NOTICE OF MEETING
PLANNING AND ZONING COMMISSION
6:00 P.M. – July 16, 2020

PLANNING AND ZONING COMMISSION ITEM:
PC-20-08
FINAL PLAT
4S RANCH, UNIT 7C

SUBJECT: 4S Ranch, Unit 7C Final Plat Acceptance
 PC-20-08

REVIEW MEMORANDUM

SUBDIVISION PLAT OF 4S RANCH, UNIT 9A

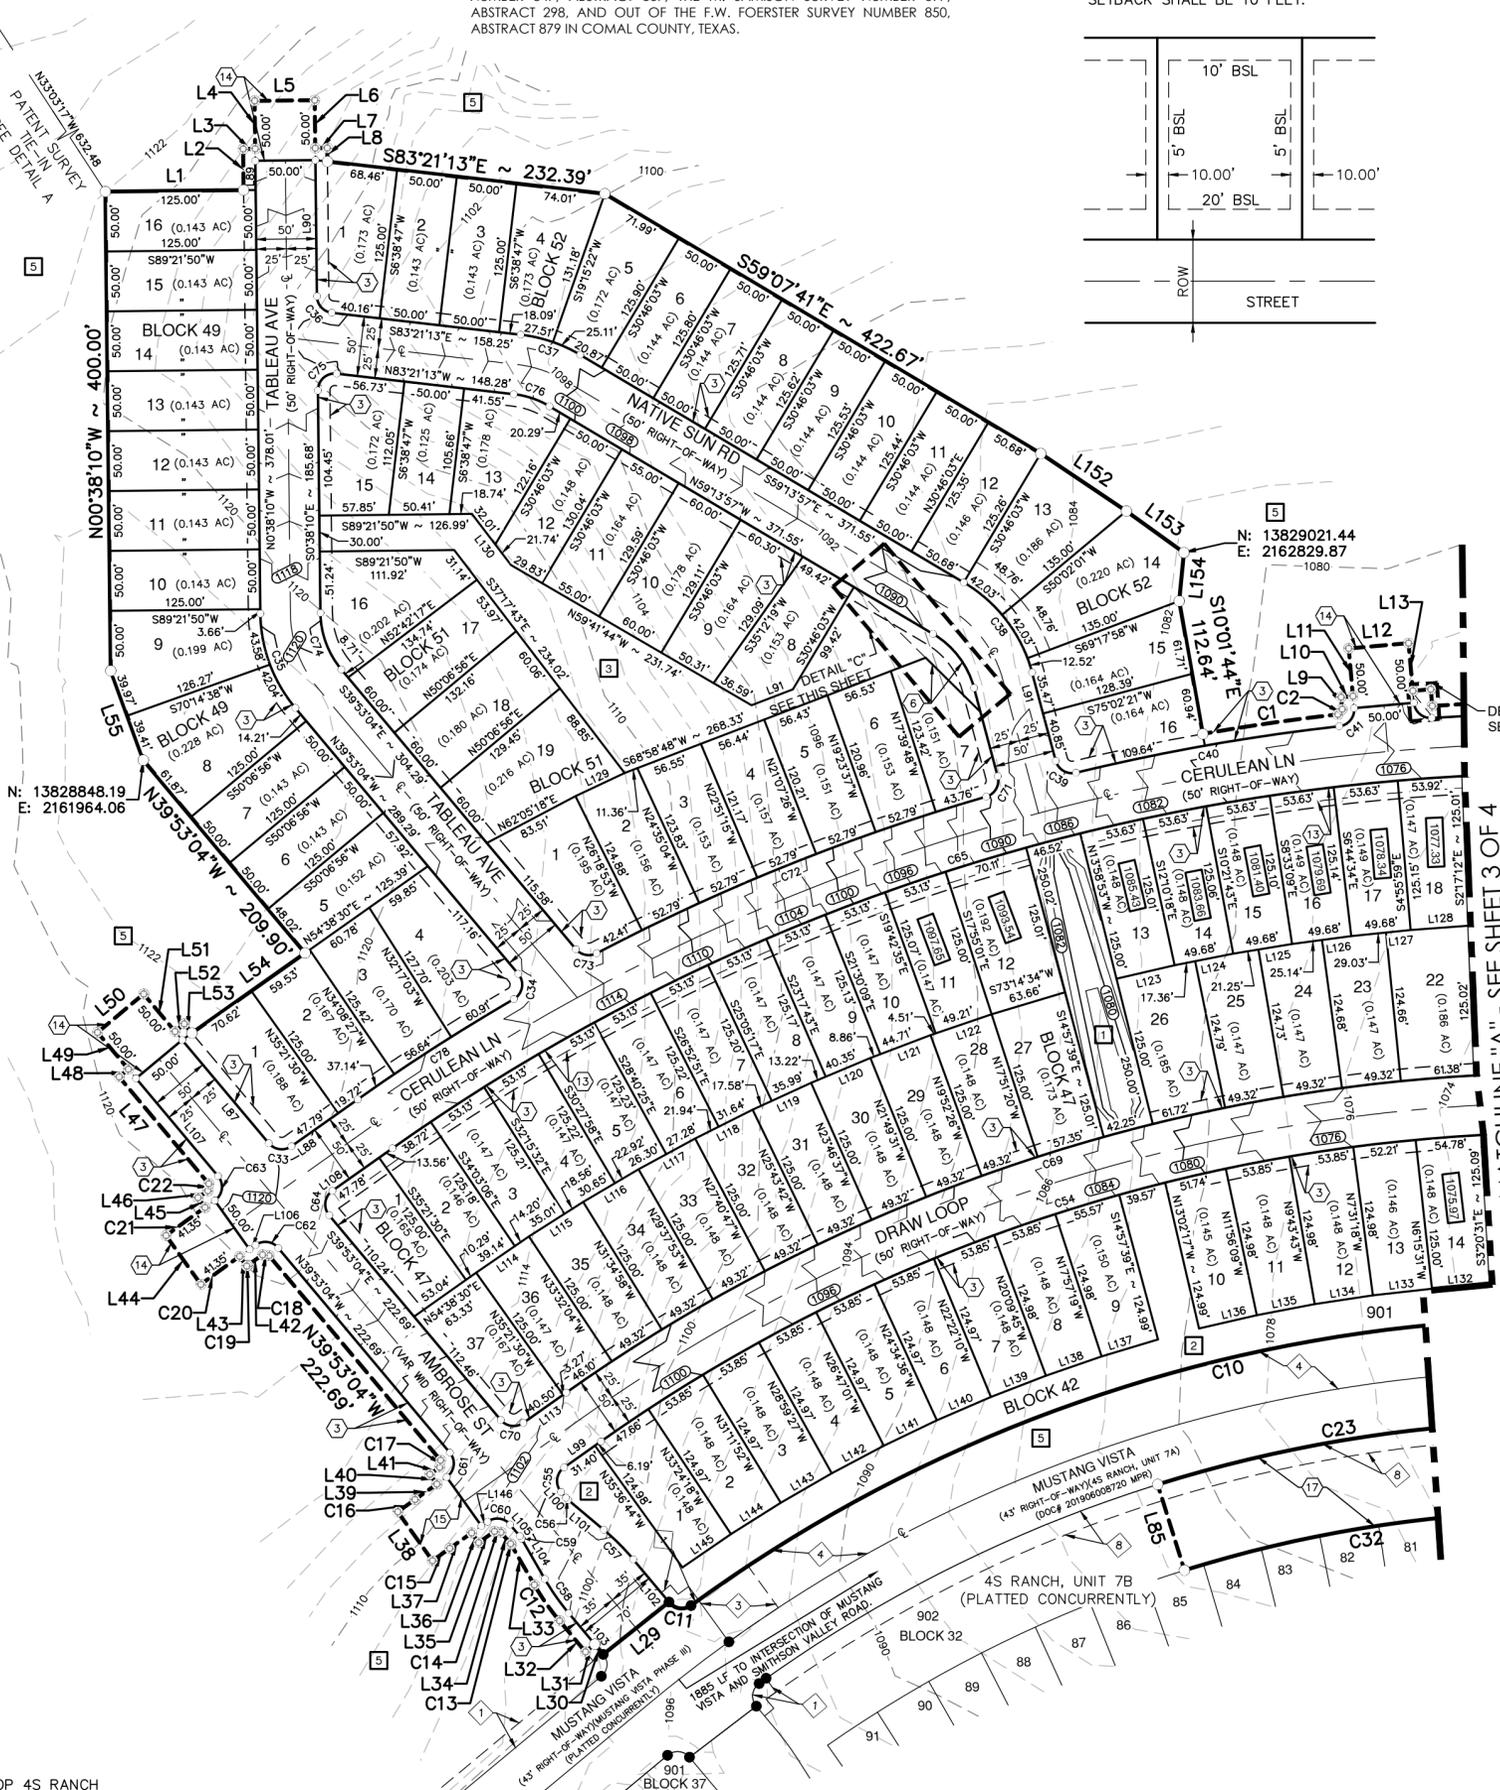
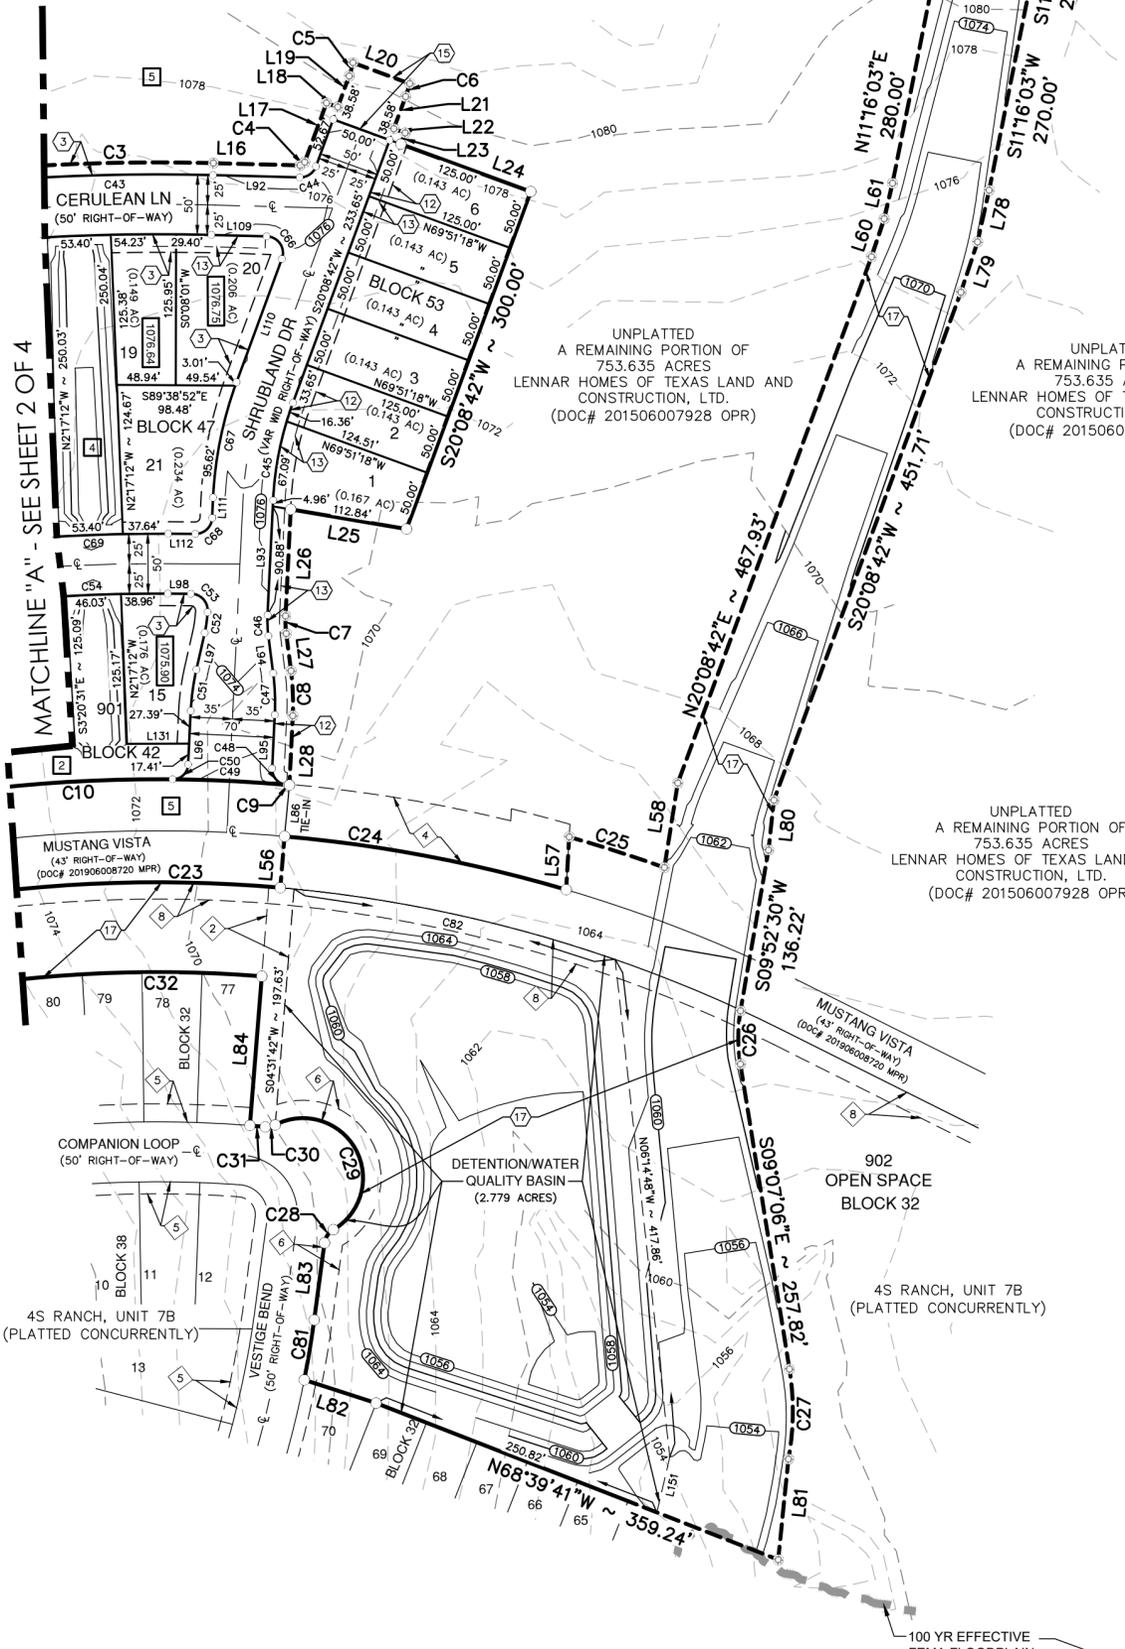
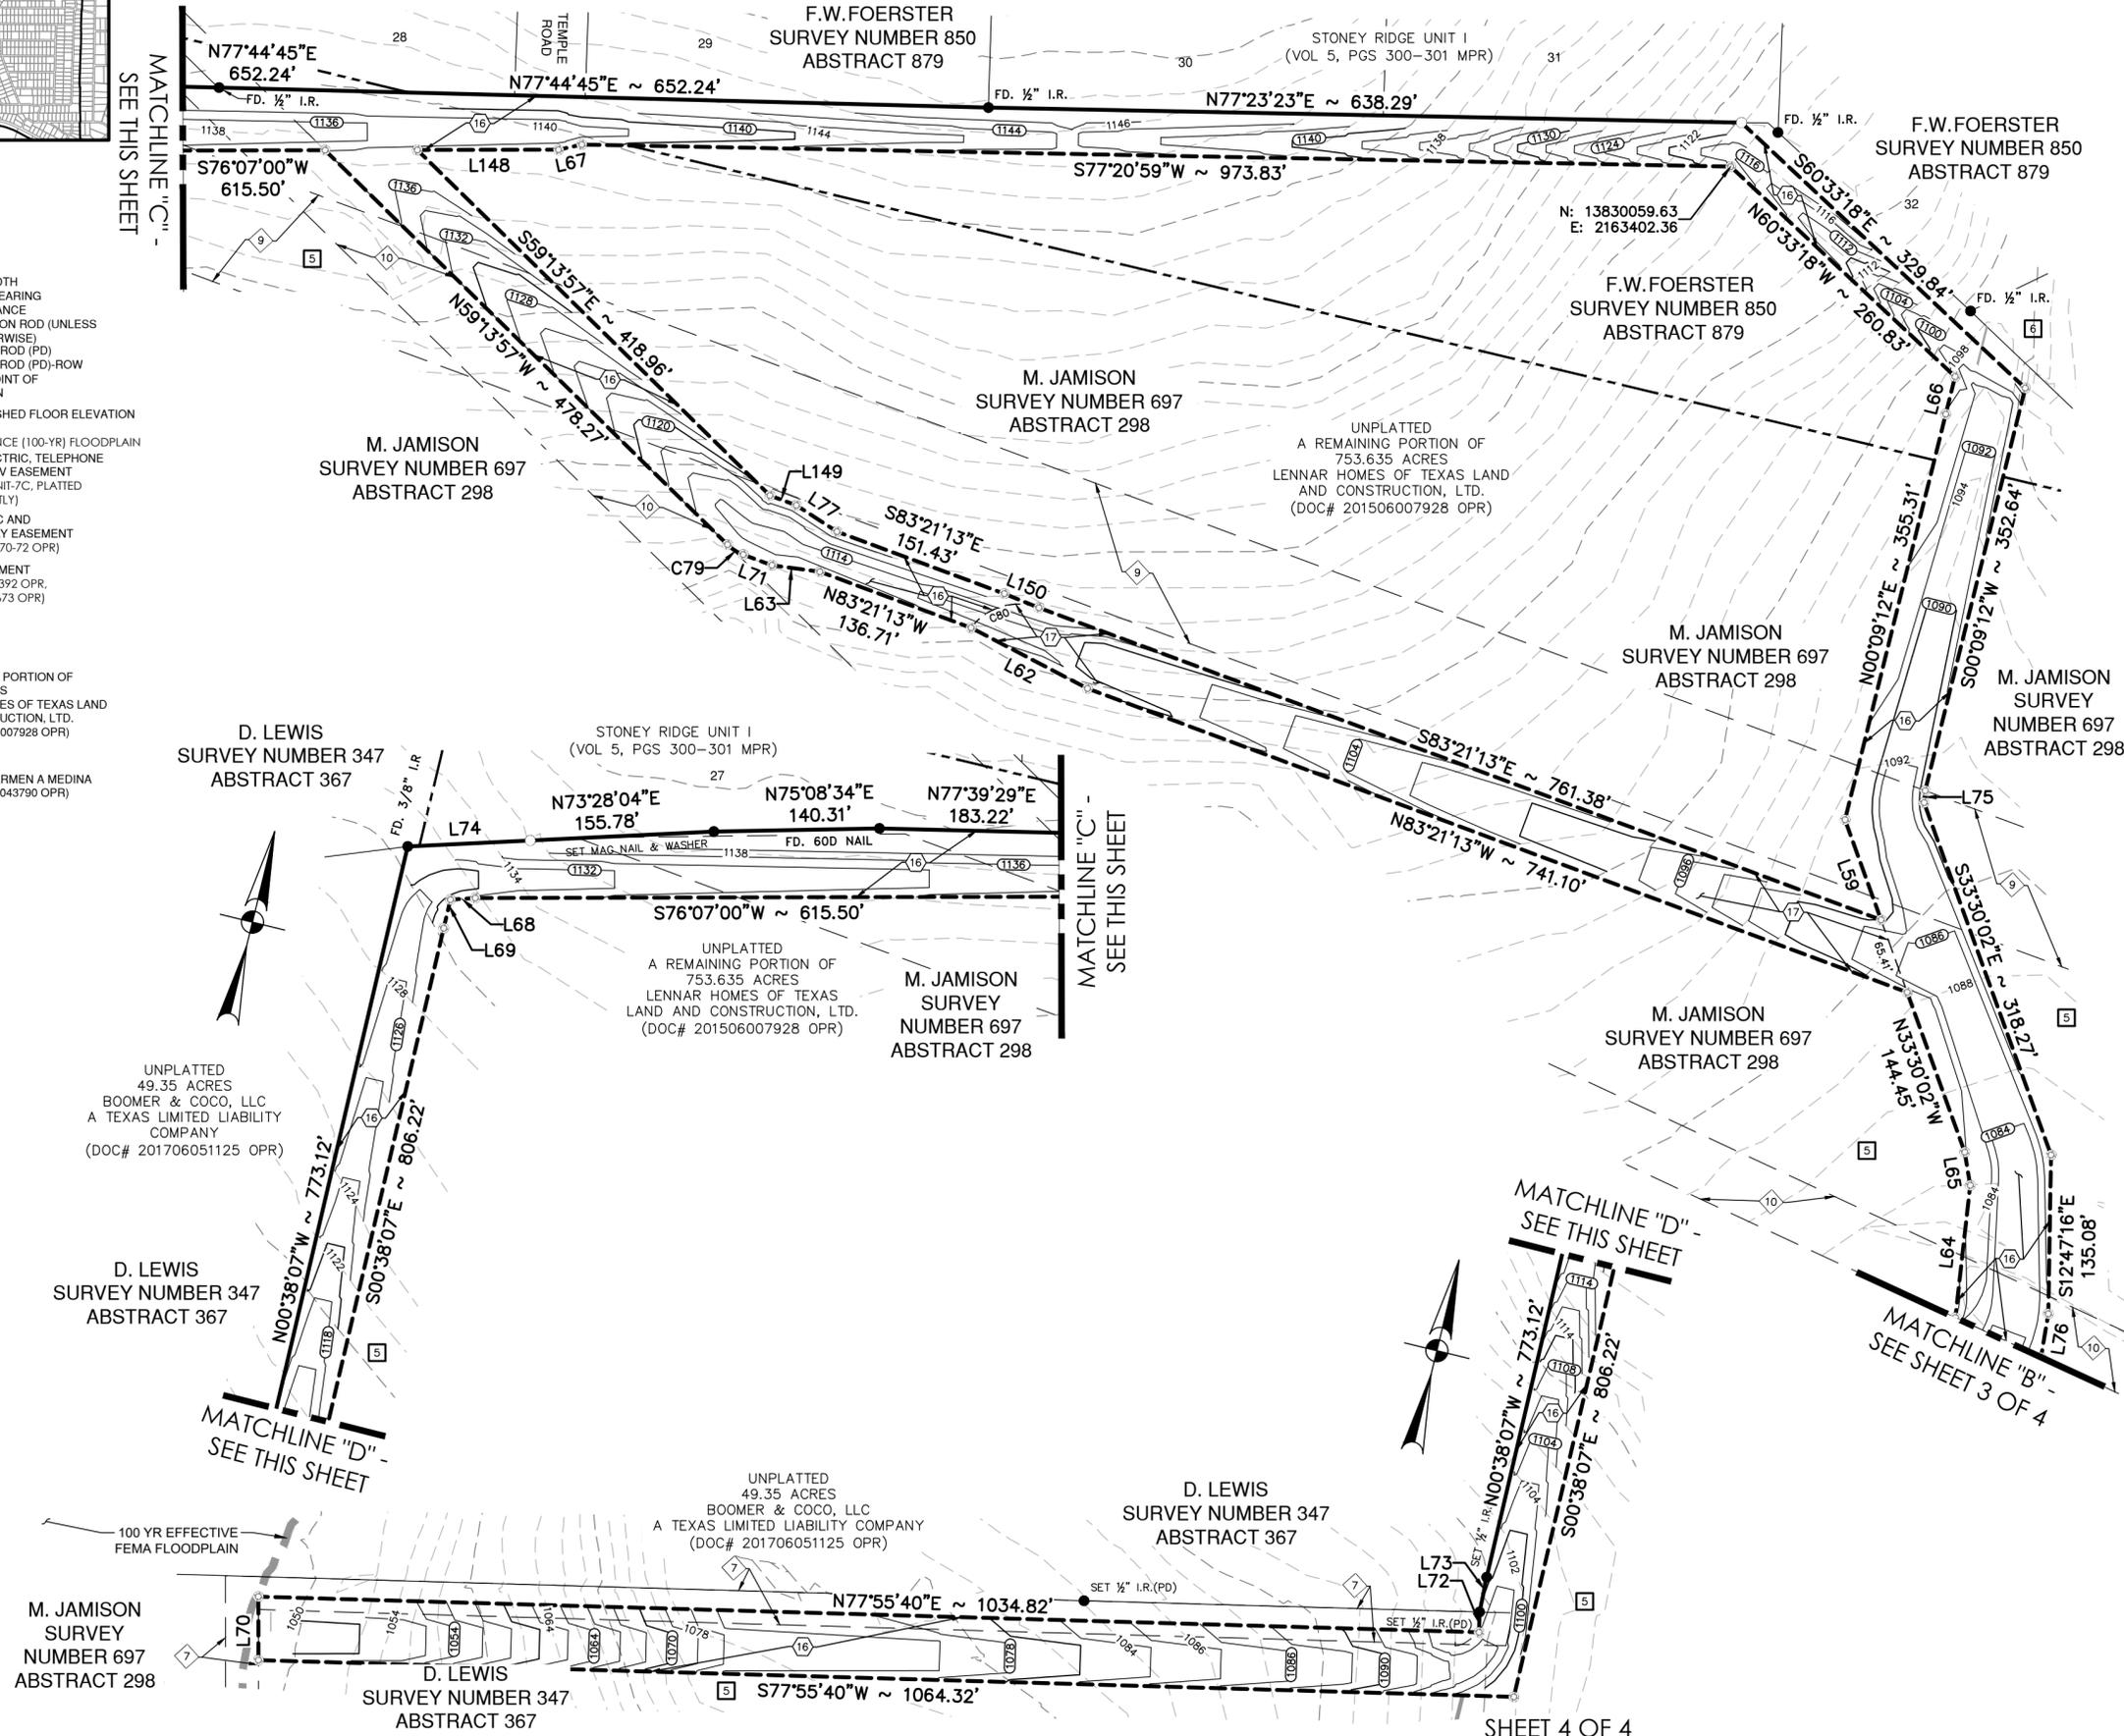
1. Provide minimum of two (2) corners referenced to state plane coordinate system – **comment resolved...added to Sheet 2.**

2. Aspect Ratio exceeds 3:1 for lots less than 1.01 acres. Please address all lots that do not meet the aspect ratio. – **comment resolved...lot lengths have been revised to meet 3:1 aspect ratio.**

3. Minimum frontage of 45 feet. Please address all lots that do not provide minimum frontage. – **comment resolved...The setback lines for the lots in question (Lot 13 and Lot 14, Block 52) have been shown on the plat and dimensioned. Per our discussion with City of Bulverde staff, if the width of the lot at the setback line is equal to or greater than 45 feet, then the lots will be considered in compliance.**
